Proper Position for the Pilot Assembly for the ULN Residential Gas Atmospheric

Technical Service Bulletin

**Pilot Location Details**

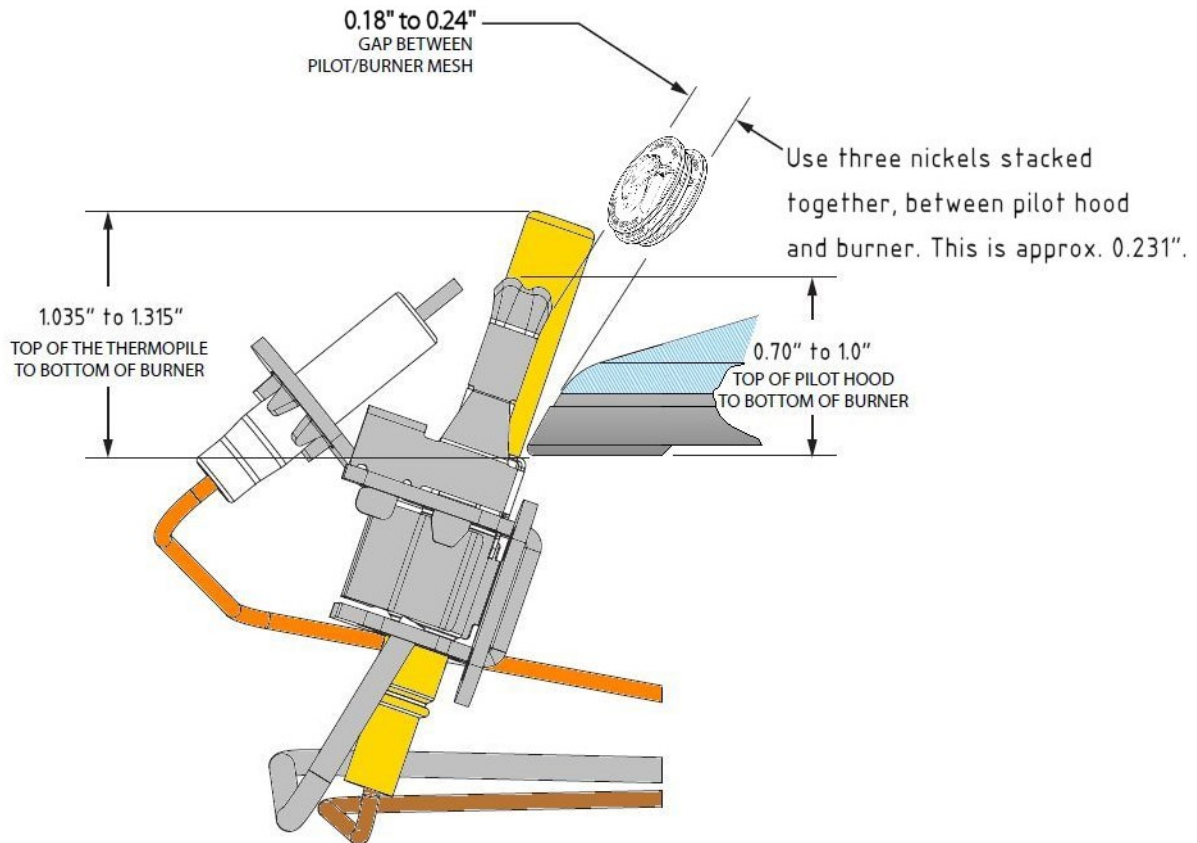
Rheem has become aware that in limited production quantities, the ULN atmospheric models may experience pilot outages causing intermittent operation of the burner. If you experience this issue, please check pilot's position using the following information.

The above picture illustrates the proper position for the pilot assembly for the ULN residential gas atmospheric heaters with mesh type radiant burner. Pilot assembly out of position can create problems of the water heater staying lit.

Once the pilot is mounted, ensure the screws are tight and the spacing is correct. Ensure the pilot bracket assembly is also mounted securely.

- Just under a  $\frac{1}{4}$ " gap between pilot hood and burner mesh.  
\*(you can use 3 nickels, or 3 quarters.)
- Approximately  $\frac{7}{8}$ " top of pilot hood to bottom of burner.
- Approximately  $1 \frac{3}{16}$ " from top of thermopile to bottom of burner.

\*Note: Nickel has a thickness of 0.077". Quarter has thickness of 0.069".

After insuring the position of the pilot is to the correct gap dimensions, the ignition process can be followed per the instructions on the unit or in the Use & Care manual. Any gas valve error code related to the pilot position will clear and allow for proper burner operation.
